Reg. No. W0265-01

Notification under Section 42(1I)(e)(iii) of the Waste Management Act 1996 as amended (The Act).

I refer to our previous notification to you requesting comments in relation to a licence application received from Clashford Recovery Facility Limited in respect of their facility located at Naul Townland, Naul, Co. Meath, Licence Reg. No. W0265-01.

Encl. Extract from Figure No. B.2.2 dated 16/03/16

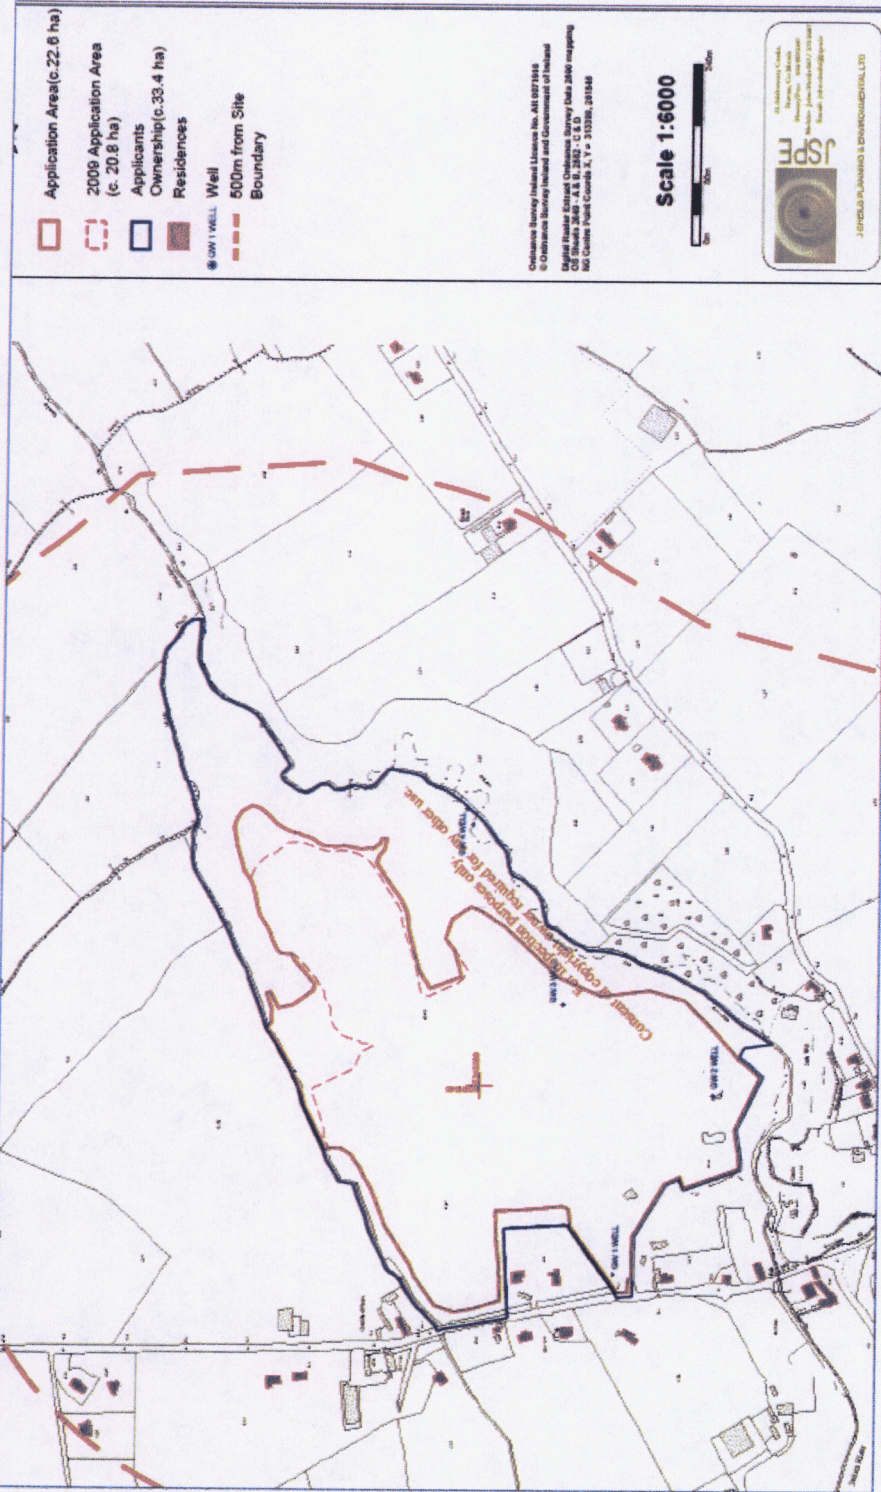
2. The licence application documentation specifies various site boundaries for the facility, as shown in the enclosed extract from Figure No. B.2.2 dated 16/03/16.

- Please state which if any of the following areas outlined in figure B.2.2 was subject to the Section 261 Registration (file ref. number QY/36):
 - the area referred to as “2009 Application area (c. 20.8 ha)”; or,

- the area referred to as “Application Area (c. 22.6 ha)”.
 - If none, please provide information on the site boundary associated with the Section 261 Registration.
